Access Compliance Report

Public Rights-of-Way

Intersection ID: 27855	Main Street: LUNDIN_LINKS_LN	Cross Street: PINE_VALLEY_CLUB_DR	Location: NW
ADA ID: 49876A7F84BC	Ramp Type: Perp	Initial Pass/Fail: Fail	Overall Compliance: No Severity Score: 33.75
Codes/Mitigation Info/Possible Solution		Field Measurements/Component Compliance

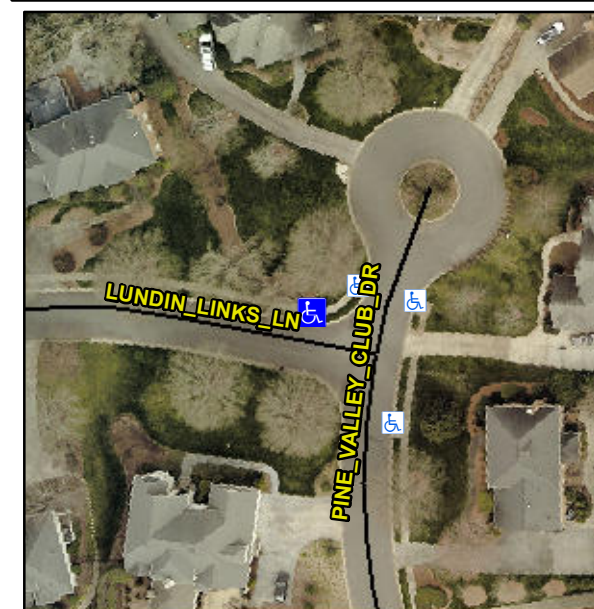
Not Found, R304.5.1, R304.2.2

Compliance	Description	Data	Compliance	Description	Data
N/A	Ramp Length (in)	46.0	No	Ramp Slope (%)	12.5
No	Ramp Width (in)	43.0	Yes	Ramp XSlope (%)	1.1
N/A	Flare Type LT	N/A	N/A	Flare Type RT	N/A
N/A	Flare Slope LT (%)	N/A	N/A	Flare Slope RT (%)	N/A
N/A	Flare Traversable LT?	N/A	N/A	Flare Traversable RT?	N/A
N/A	Landing Length (in)	N/A	N/A	DWS Provided?	N/A
N/A	Landing Width (in)	N/A	N/A	DWS Contrast?	N/A
N/A	Landing Slope (%)	N/A	N/A	DWS Length (in)	N/A
N/A	Landing X Slope (%)	N/A	N/A	DWS Full Width?	N/A
N/A	Landing Curb? (Y/N)	N/A	N/A	DWS Offset (in)	N/A
N/A	Shared Landing?	N/A			
N/A	Gutter Ponding?	N/A	N/A	Gutter Slope (%)	N/A
N/A	Gutter Lip Ht (in)	N/A	N/A	Gutter X Slope (%)	N/A
N/A	Painted X Walk1?	No	N/A	Painted X Walk2?	N/A
	X Walk 1 Direction	To SE		X Walk 2 Direction	N/A
N/A	X Walk 1 Width (in)	N/A	N/A	X Walk 2 Width (in)	N/A
	X Walk 1 Slope (%)	5.8		X Walk 2 Slope (%)	N/A
	X Walk 1 X Slope (%)	1.1		X Walk 2 X Slope (%)	N/A

Remove & Replace Entire Ramp.
